<b>AMENDMENT OF SOLICITATION/MODIFICATION OF CONTRACT</b>				1. CONTRACT ID CODE	PAGE 1 OF 5 PAGES
2. AMENDMENT/MODIFICATION NO. AMENDMENT NO. 0002		3. EFFECTIVE DATE 09/16/08	4. REQUISITION/PURCHASE REQ. NO.	5. PROJECT NO. (If applicable) 06-0058	
6. ISSUED BY CODE		ase	7. ADMINISTERED BY (If other than Item 6) CODE		See Item 6
Officer in Charge of Construction 1005 Michael Road Camp Lejeune, NC 28547-2521					
8. NAME AND ADDRESS OF CONTRACTOR (No., street, county, State and ZIP Code)				(X)	9A. AMENDMENT OF SOLICITATION NO. N40085-06-R-0058
				x	9B. DATED (SEE ITEM 11) 09/06/08
					10A. MODIFICATION OF CONTRACT/ORDER NO.
					10B. DATED (SEE ITEM 11)
CODE	FACILITY CODE

06-0058, Major Interior/Exterior Repairs, BEQ HP275 & HP285

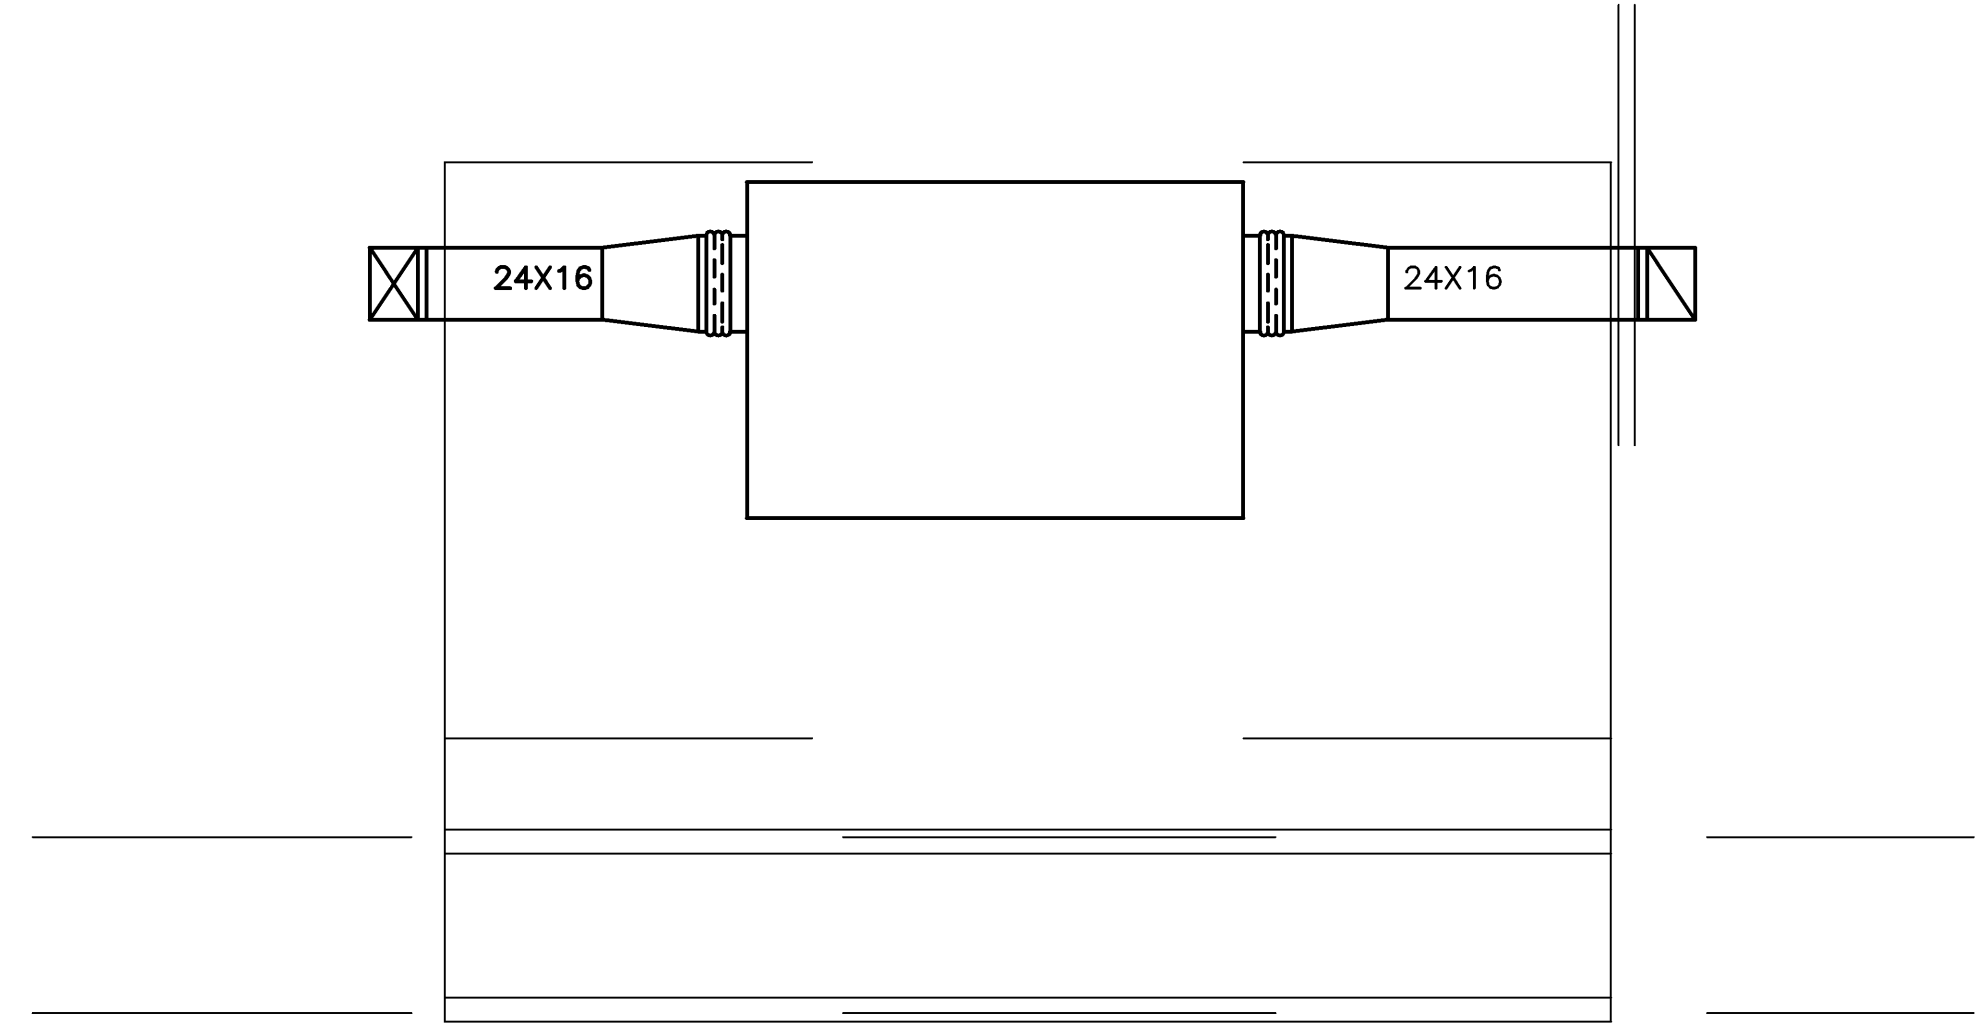
11. Question: The demolition notes # 12 says to remove all water coolers, but they are not included on the fixture schedule. Are they not being replaced?

Answer: The water coolers are being replaced. On the Plumbing Fixture Schedule P-5 is labeled incorrectly. P-5 is the Water Cooler.
